**SECTION 00 90 04
BIDDING AND CONTRACT REQUIREMENTS
ADDENDUM NUMBER 4**

Issued: October 12, 2023

Re: ADDENDUM NUMBER (4) TO THE BIDDING DOCUMENTS FOR

**McHenry County College
University Center at MCC**
Architect's Project Number: 22-050

SHEET NUMBER:
A2.51

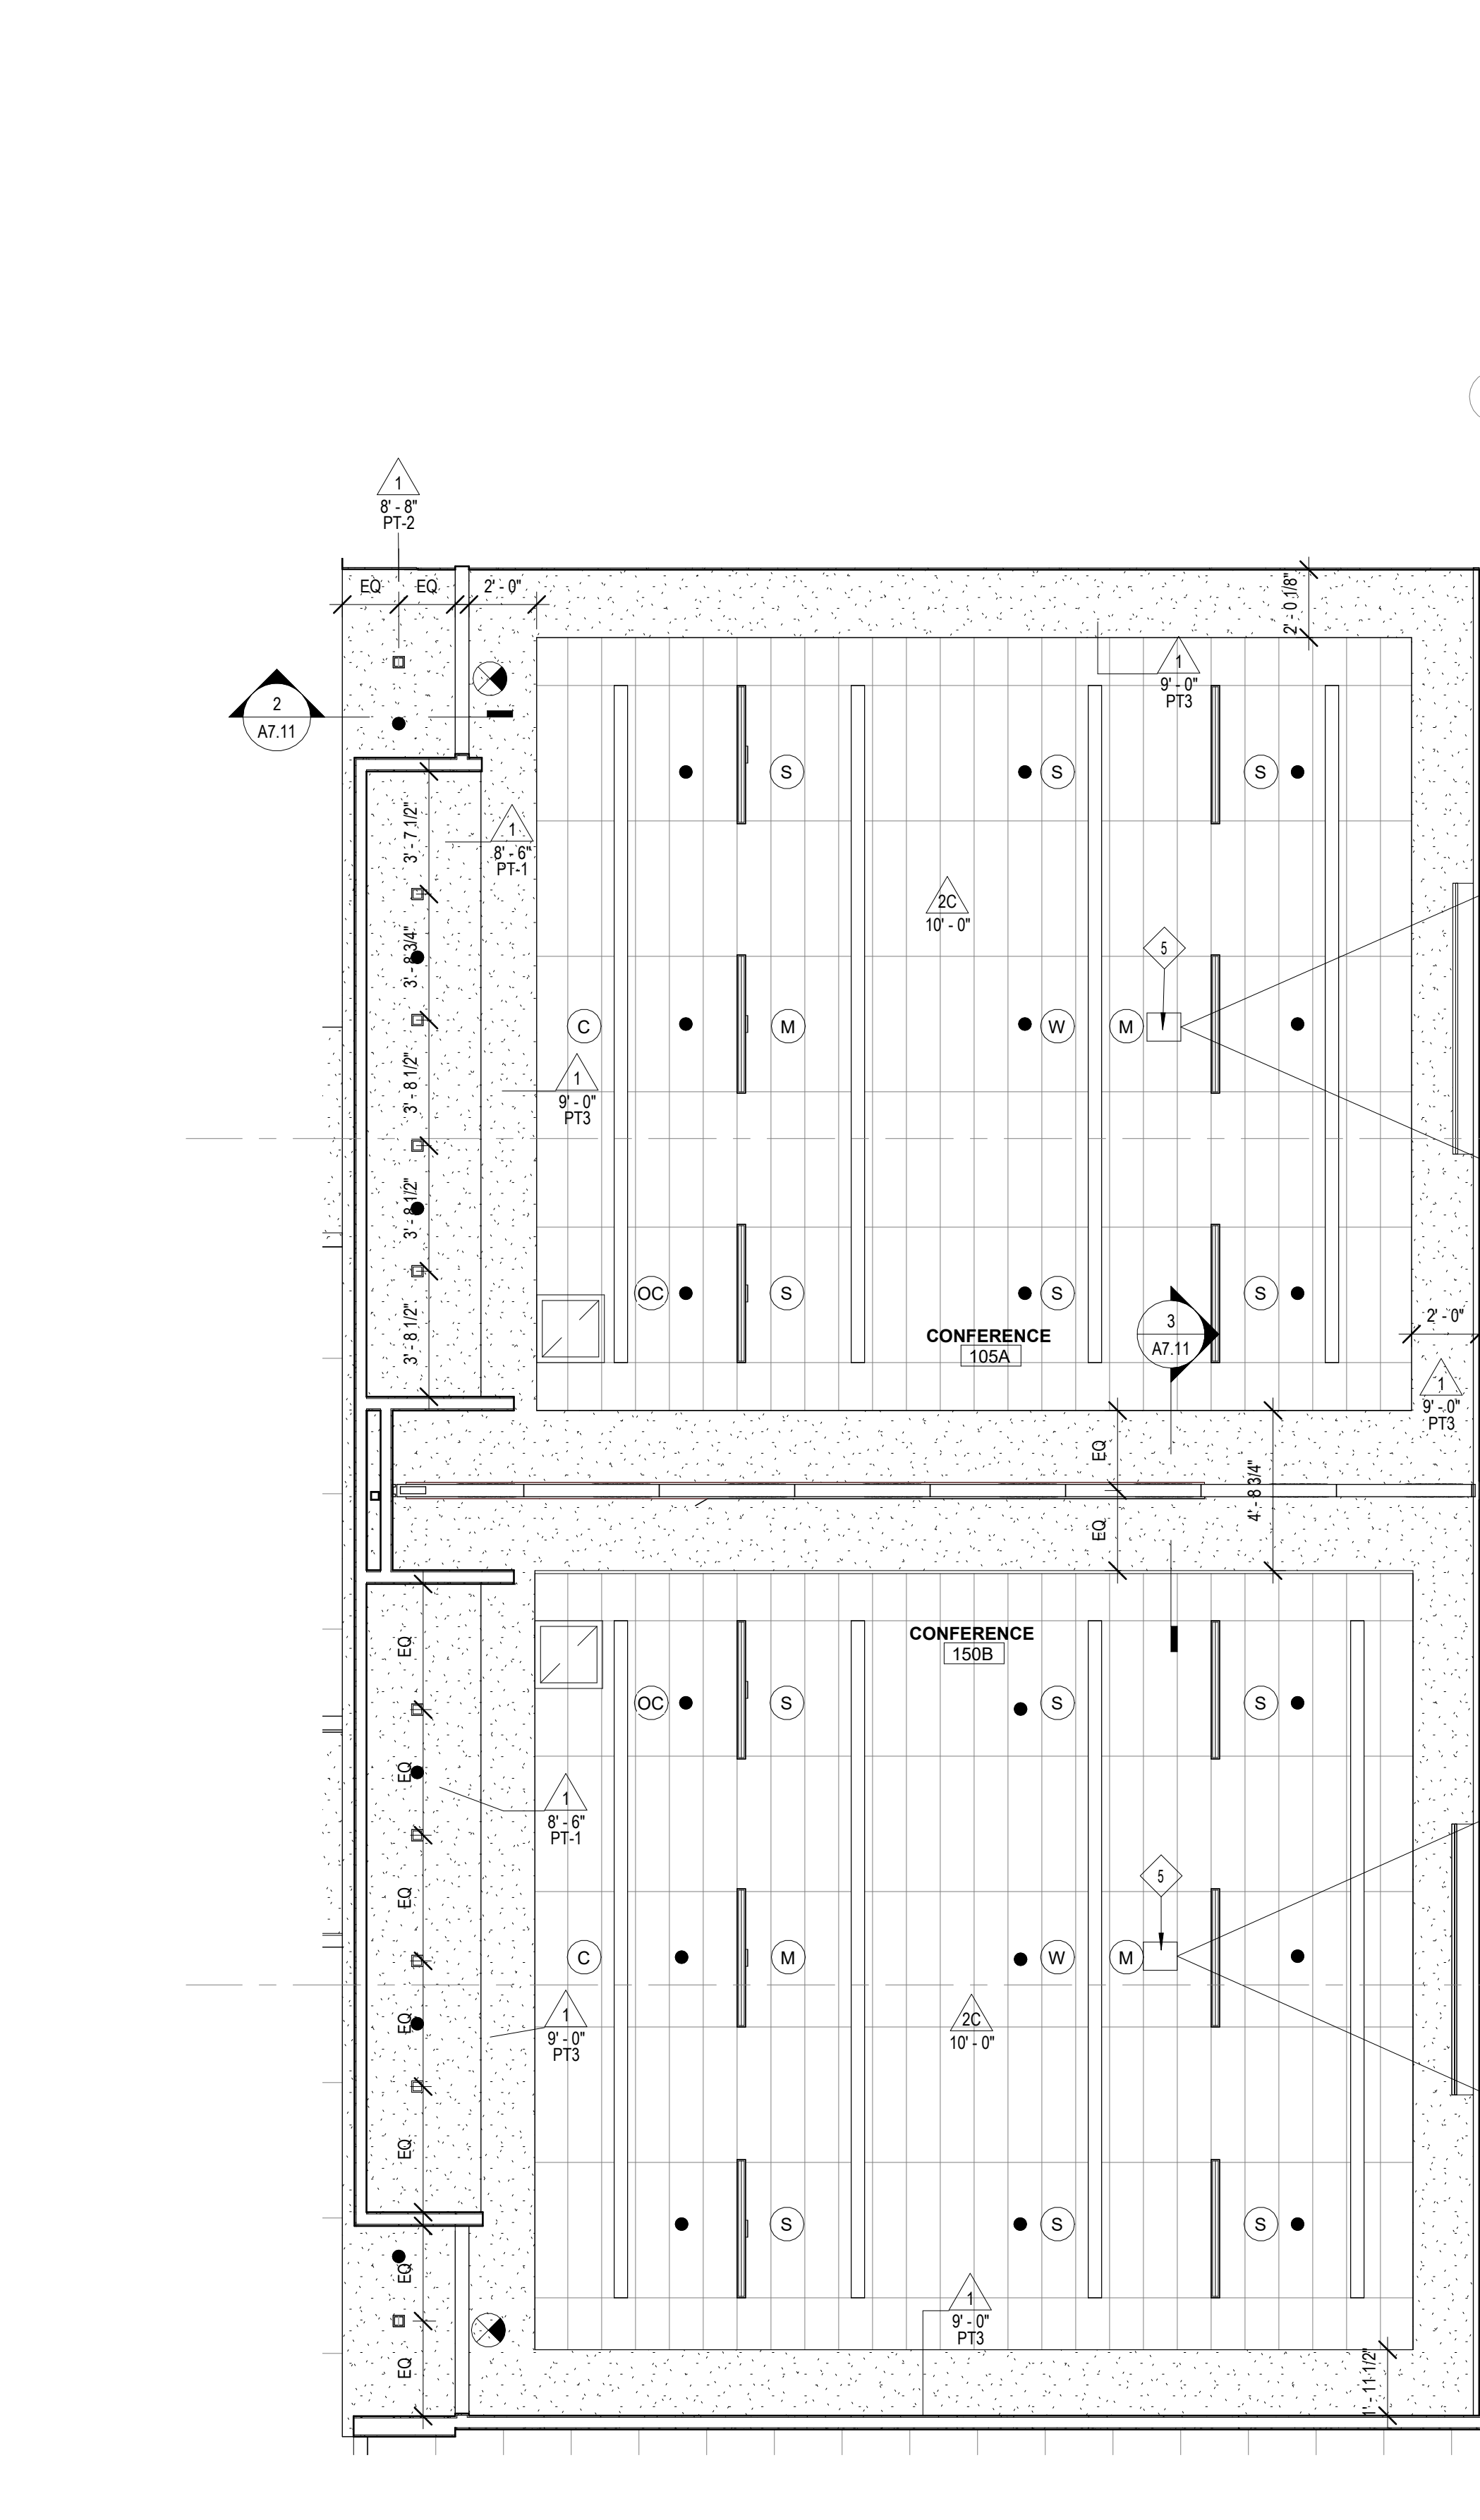
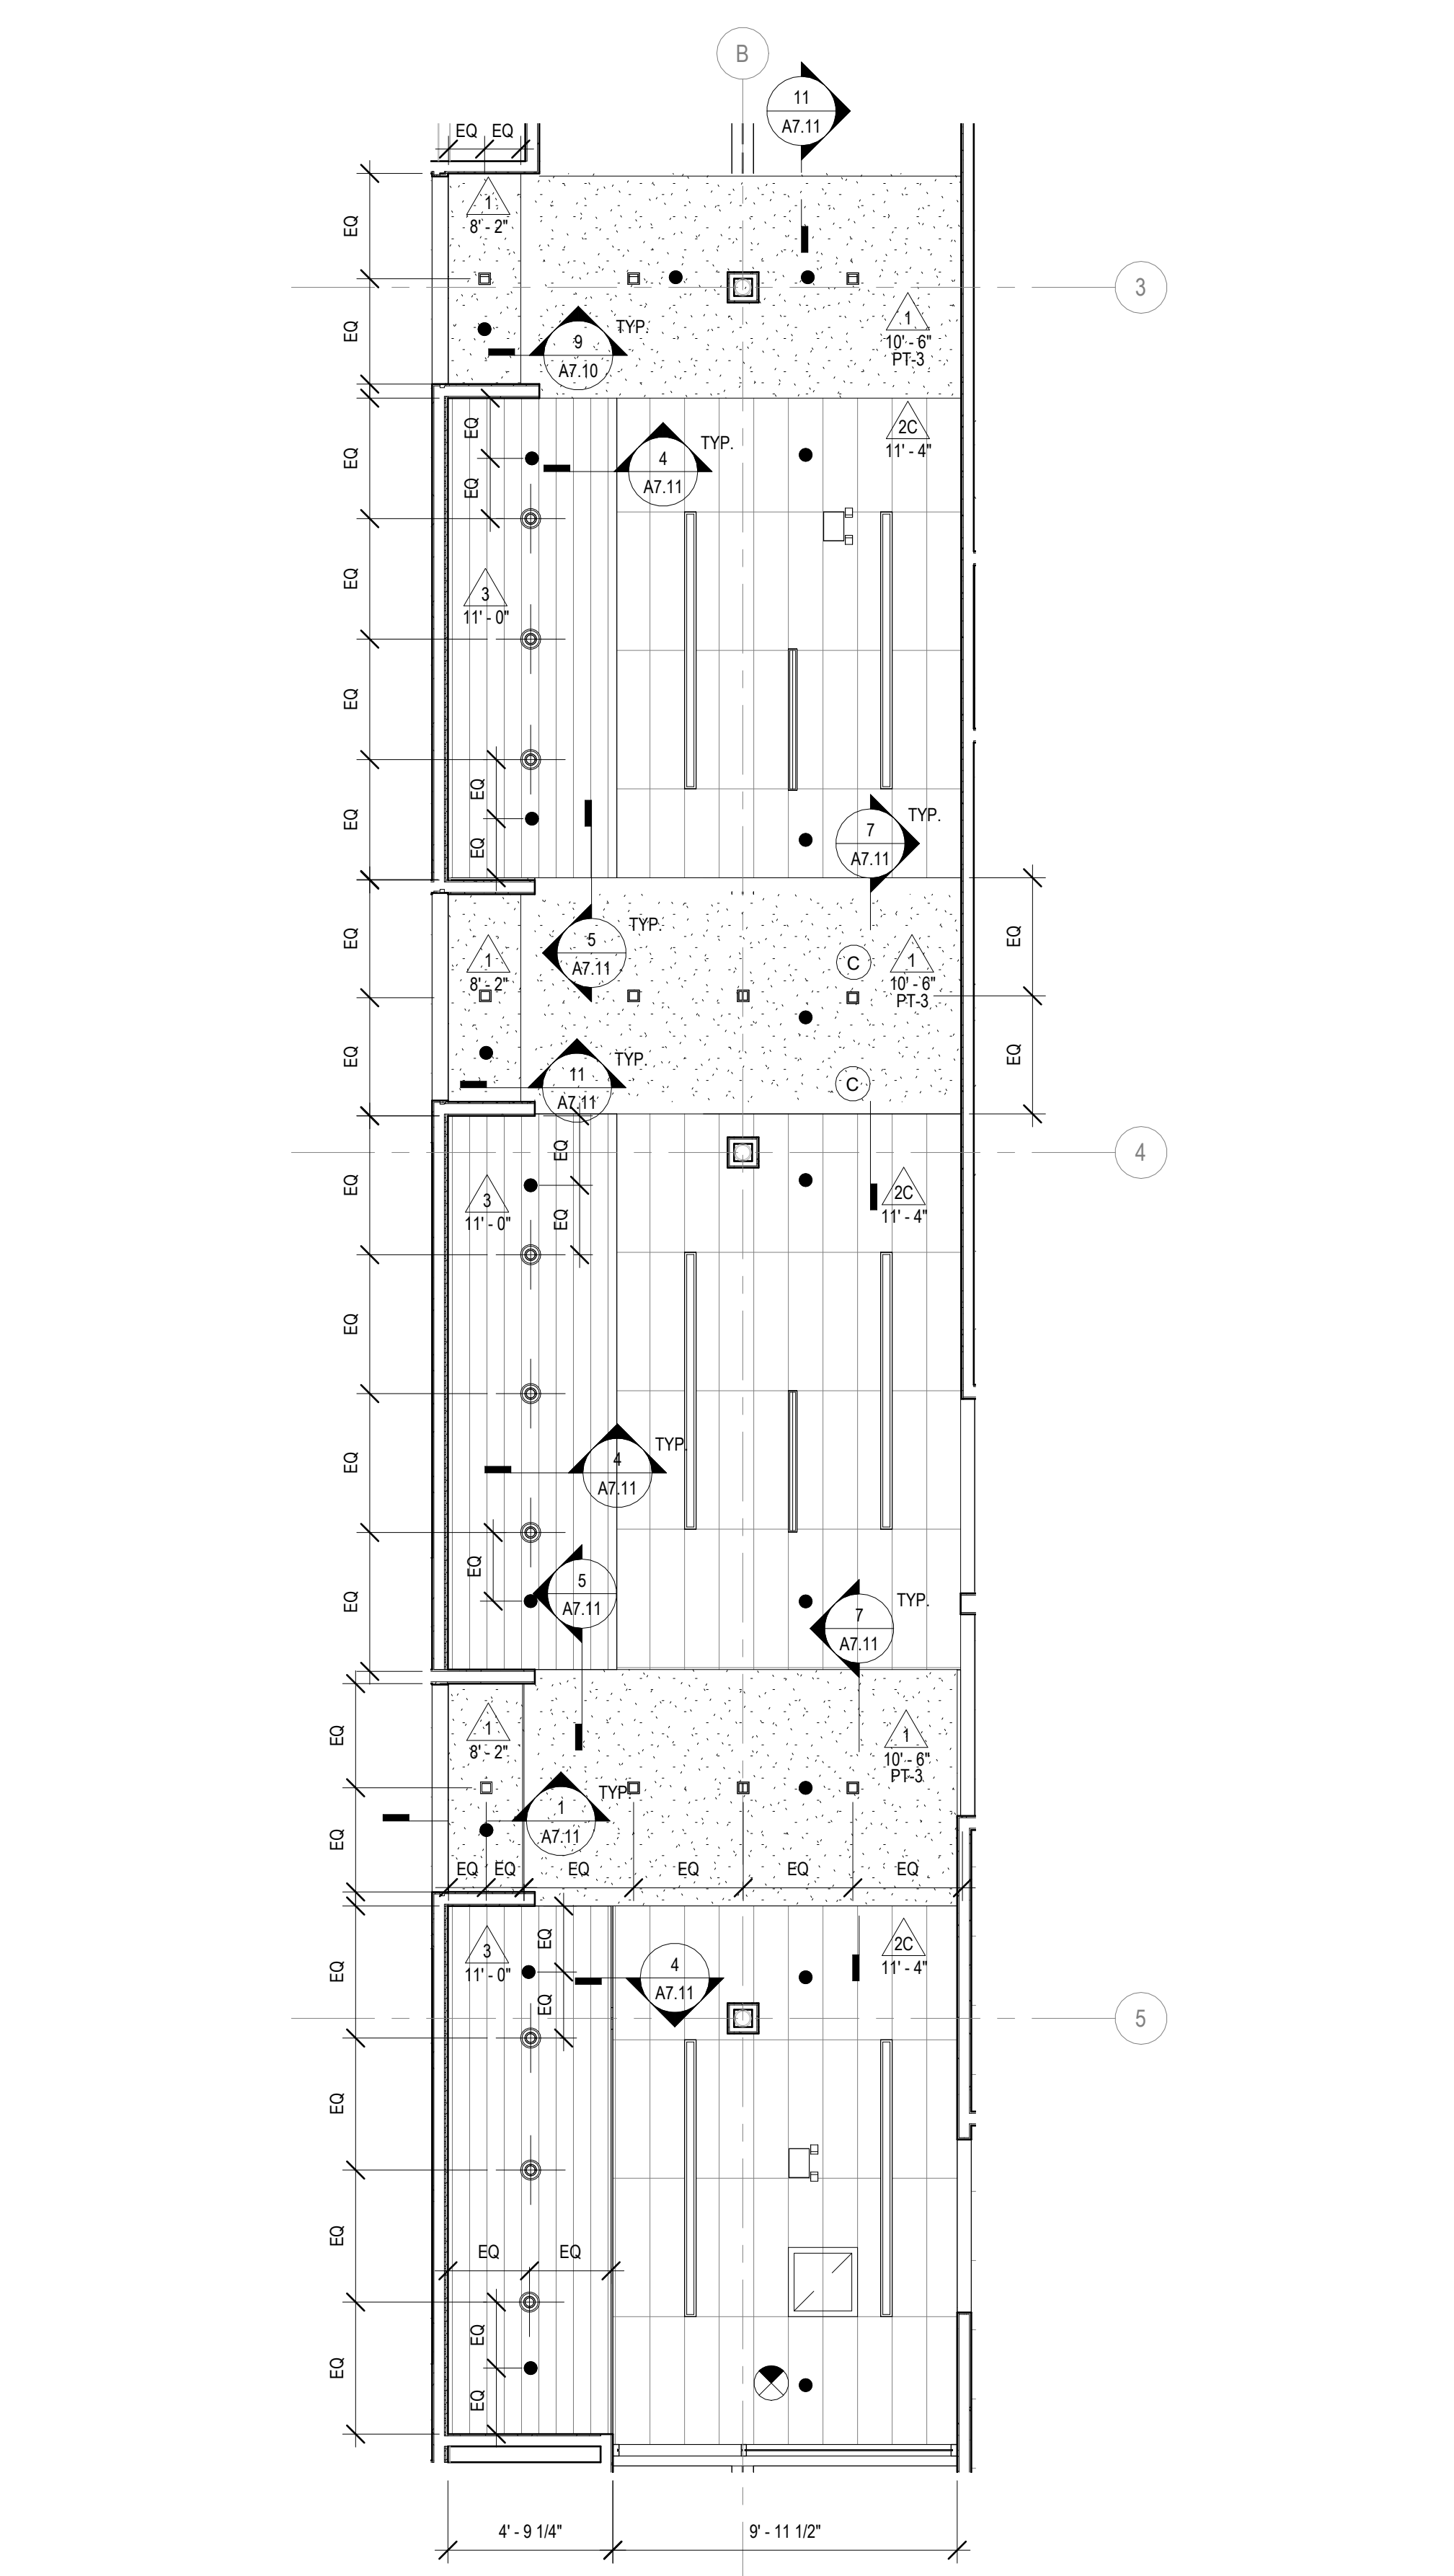
4. A2.51
 - A. **REVISE** enlarged RCP #1 as indicated.
5. A5.01
 - A. **REVISE** section 3 and 4 as indicated.
6. A7.10
 - A. **REVISE** details 7, 11, 12, 14, and 16 as indicated.
